UNITED STATES PATENT AND TRADEMARK OFFICE

10/801,858

Office Action Summary	Application No.	Applicant(s)	
	10/801,858	BAUMANN, HERMANN	
	Examiner	Art Unit	
	Thai-Ba Trieu	3748

DETAILED ACTION

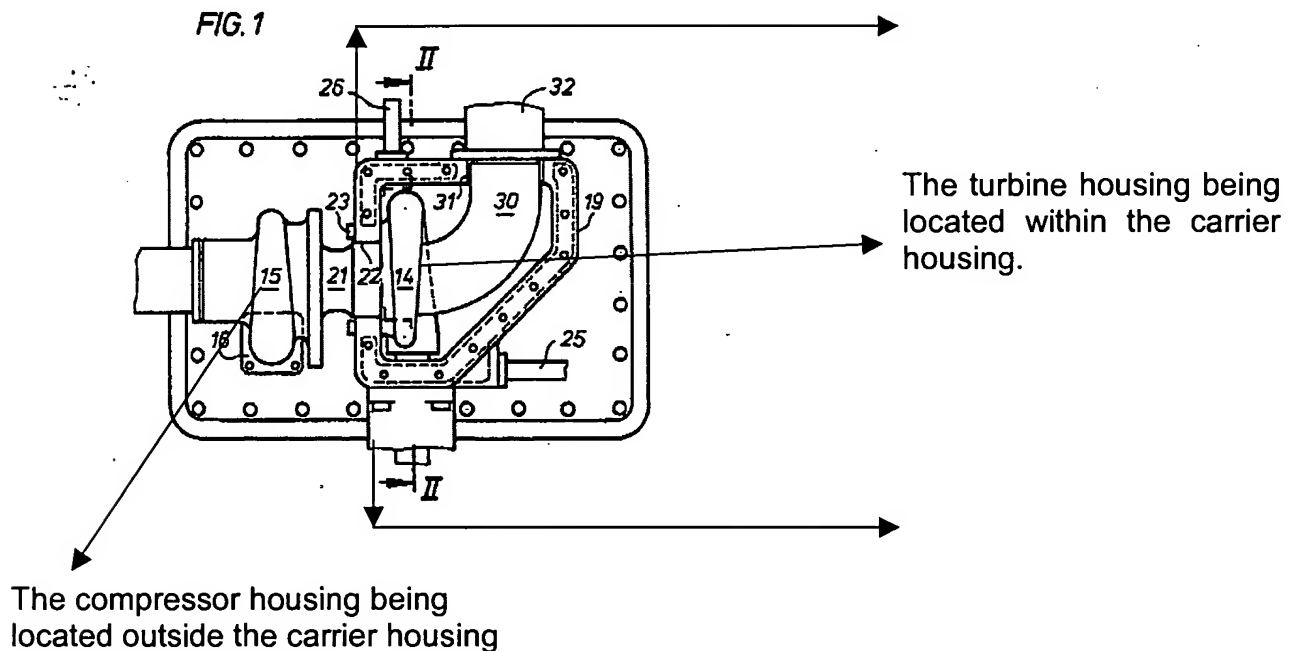
Ruf discloses an arrangement for an exhaust gas turbocharger with a carrier housing (10), the exhaust gas turbocharger (2,3) comprising:

a compressor wheel (Not shown, a well-known component of a compressor) in a compressor housing (See Figure 1),

a turbine wheel (Not shown, a well-known component of a turbine) in a turbine housing (See Figure 1),

a shaft (4) adapted to extend through the bearing housing and to connect the compressor wheel and the turbine wheel (See Figure 2, and Column 2, lines 17-18).

However, Ruf fails to disclose the location of the turbine housing and the compressor housing; as well as, the recitation of "the bearing housing being mounted in and attached to the carrier housing by way of a fastening element in a direction perpendicular to an axis of rotation of the shaft".

Norbert teaches that it is conventional in the turbocharger art, to position the turbine housing within the carrier housing and the compressor housing outside the carrier housing (See attached Figure 1; Page 3, line 17-27; and Page 1, Paragraph [0003] of instant application).
